Access Compliance Report

Public Rights-of-Way

(Pedestrian Signals)

Intersection ID: N/A	Main Street:	Cross Street: N/A	Location: N/A
ADA ID: 93BF50696950	Signal Type: One Push Button-Non APS	Overall Compliance: No	Severity Score: BTN 1: N/A BTN 2: N/A No BTN: N/A
Codes/Mitigation Info/Possible Solution		Field Measurements/Component Compliance

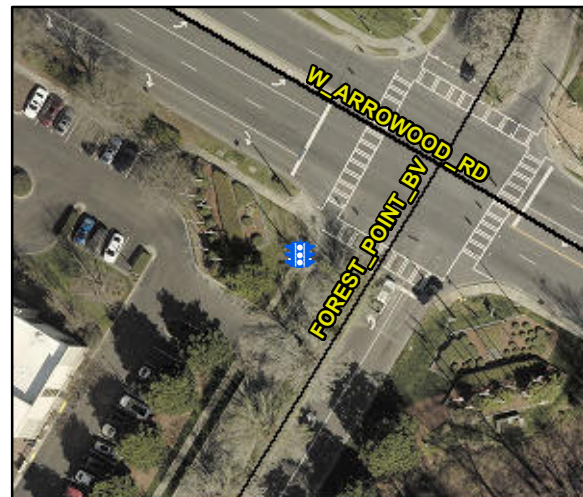
Surveyor Notes: TEXT HT 1/2"

PROW/ADA: R410.6, TMUTCD 4e.08, R406.2

Possible Solutions: Replace Signal Push Button With APS Button on New Post. Remove & Replace Sign.
